South Dublin County Council

Knocklyon to Ballyboden Active and Sustainable Travel Scheme

Part 8 Chief Executive's Report to Council Members

11th May 2026

Figure 9: New footway and zebra crossing at St. Colmcille's (Sheet 09)

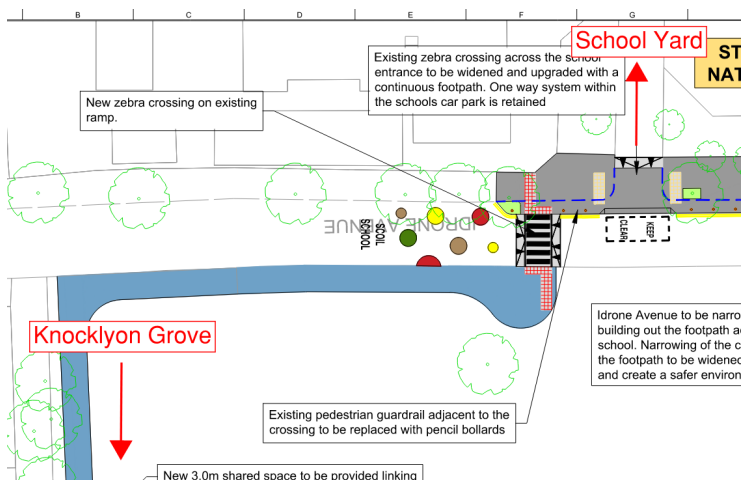
Concerns were raised regarding the need for improved walking link between Knocklyon Road and St. Colmcille's via. Coolamber Park and the need to improve the existing crossing of Knocklyon Road. Submissions noted that this improvement was recommended in the Safe Routes to School Outline Delivery Plan and it's a busy corridor for pupils arriving to school on foot or bicycle. A submission also requested that the existing kissing gate between Cremorne and Coolamber Park is removed.

The proposed zebra crossing, which serves the new pathway connecting Knocklyon Grove and St. Colmcille's, is located approximately 5 metres north of the laneway used to access the yard. It is positioned along the natural desire line for pupils travelling from Knocklyon Grove.

The laneway is also serves as a fire tender access and therefore cannot be obstructed with a zebra crossing and associated signage.
